February 3, 2020

ADDENDUM NUMBER 5
TO THE DRAWINGS AND SPECIFICATIONS

PROJECT: McLean County Unit District No. 5 Kingsley Junior High School HVAC Renovation
and Geothermal

A/E PROJECT NO: 23152318

Kingsley Junior High Lighting/Controls Layout no FC Levels

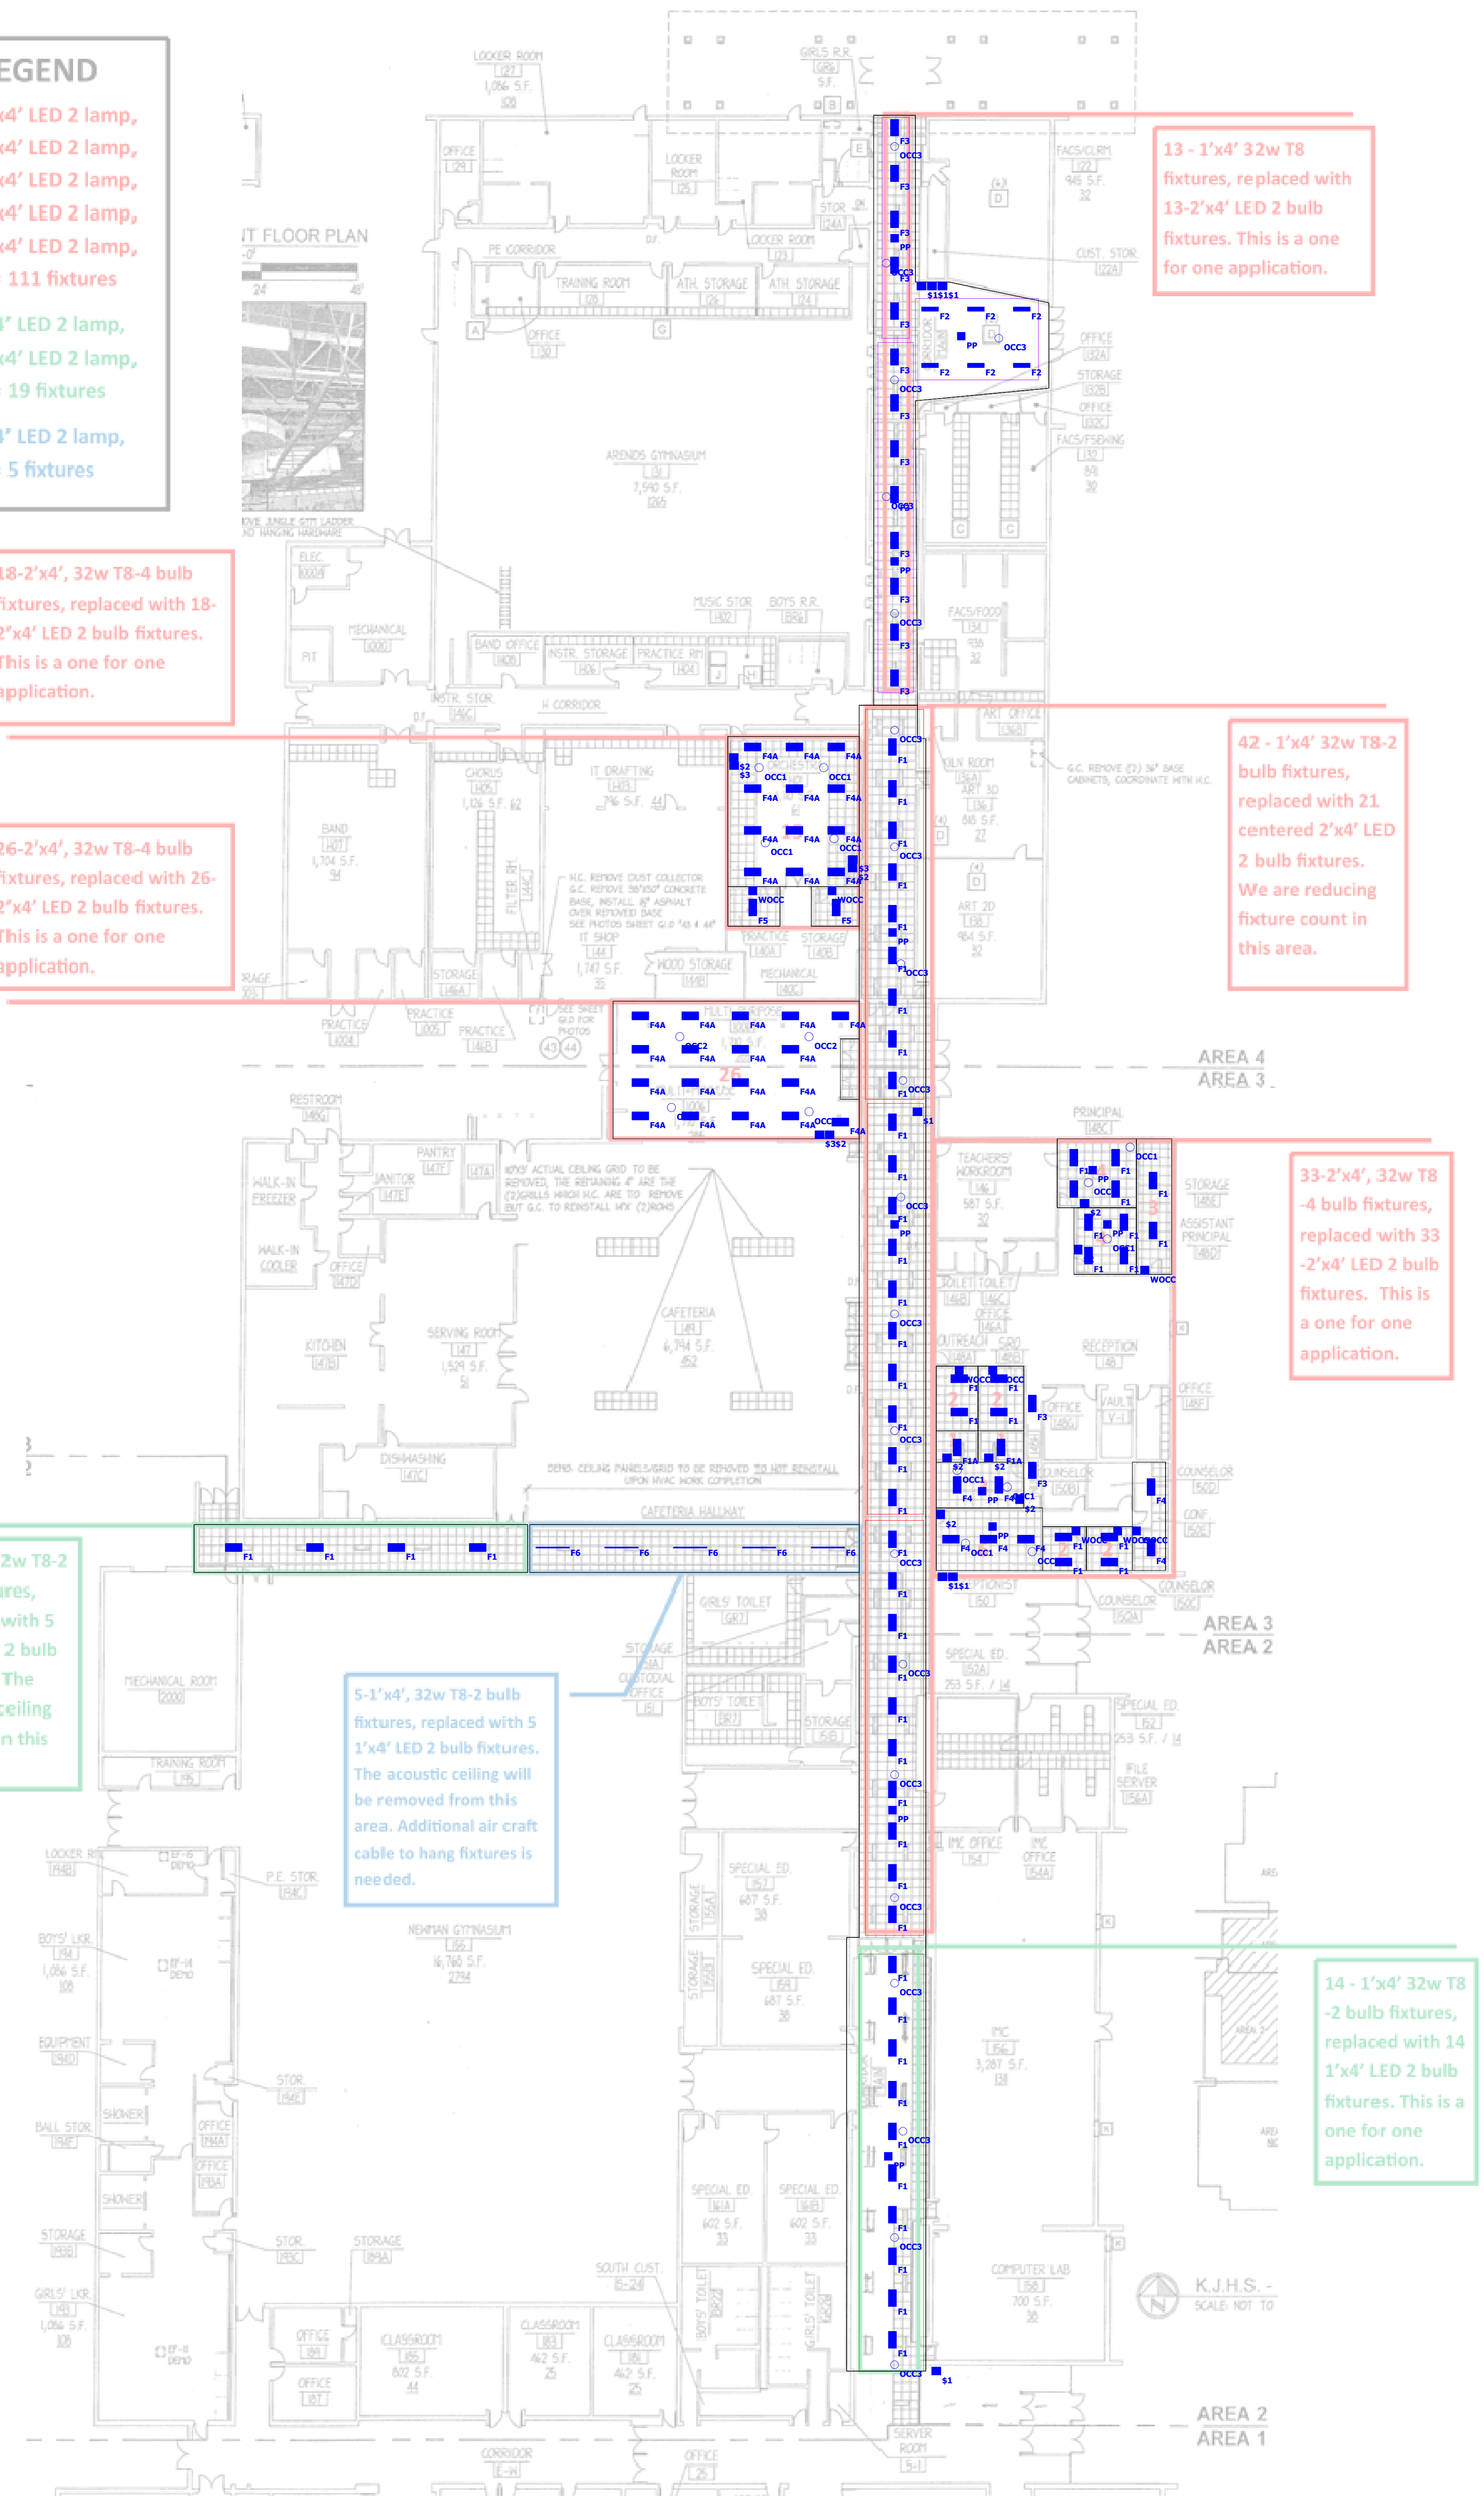
18-2'x4', 32w T8-4 bulb fixtures, replaced with 18-2'x4' LED 2 bulb fixtures. This is a one for one application.

26-2'x4', 32w T8-4 bulb fixtures, replaced with 26-2'x4' LED 2 bulb fixtures. This is a one for one application.

13 - 1'x4' 32w T8 fixtures, replaced with 13-2'x4' LED 2 bulb fixtures. This is a one for one application.

42 - 1'x4' 32w T8-2 bulb fixtures, replaced with 21 centered 2'x4' LED 2 bulb fixtures. We are reducing fixture count in this area.

33-2'x4', 32w T8-4 bulb fixtures, replaced with 33-2'x4' LED 2 bulb fixtures. This is a one for one application.

5-1'x4', 32w T8-2 bulb fixtures, replaced with 5 1'x4' LED 2 bulb fixtures. The acoustic ceiling remains in this area.

5-1'x4', 32w T8-2 bulb fixtures, replaced with 5 1'x4' LED 2 bulb fixtures. The acoustic ceiling will be removed from this area. Additional air craft cable to hang fixtures is needed.

14 - 1'x4' 32w T8-2 bulb fixtures, replaced with 14 1'x4' LED 2 bulb fixtures. This is a one for one application.
